# MATANUSKA-SUSITNA BOROUGH

#### **ABBREVIATED PLAT AGENDA**

**September 6, 2023**

# STAFF REVIEW AND RECOMMENDATIONS PUBLIC HEARING SEPTEMBER 6, 2023

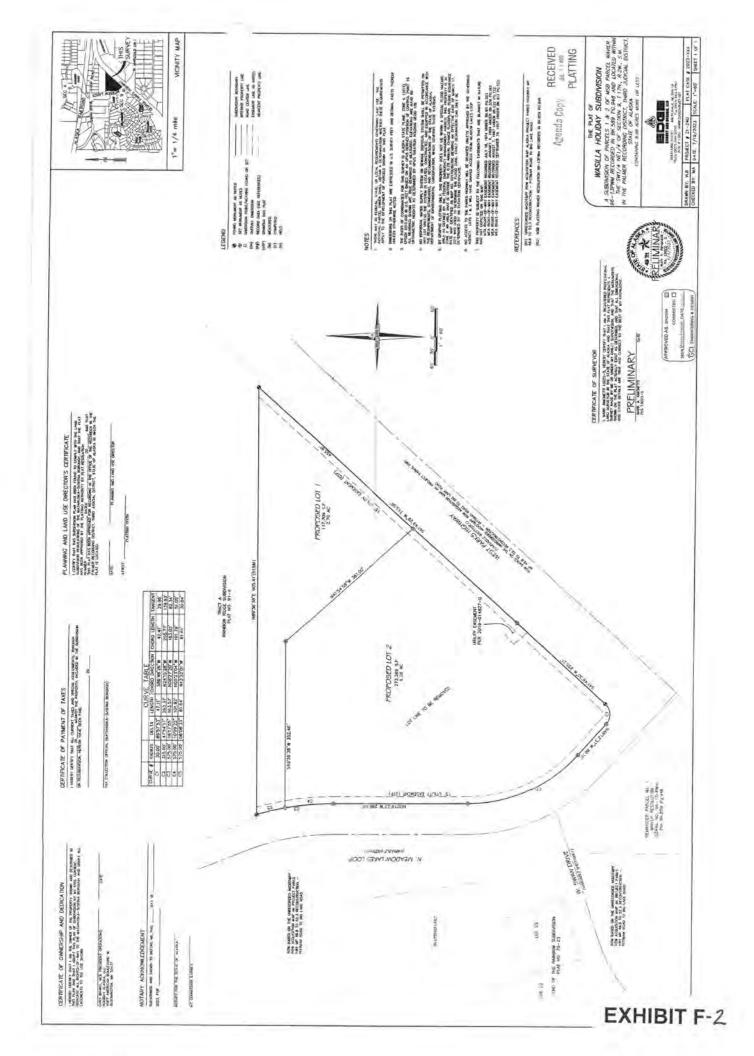
- 1. Add a note which says, "There is a ten foot (10 FT) wide natural gas easement centered on existing service line." And add, "location of natural gas main and centerline of ten foot (10 FT) wide natural gas easement" to the depiction of the referenced service line.
- 2. Owner signs an ENSTAR Natural Gas Easement document for a ten foot (10 FT) wide natural gas easement, centered on the service line at this location. MEA and MTA did not respond.
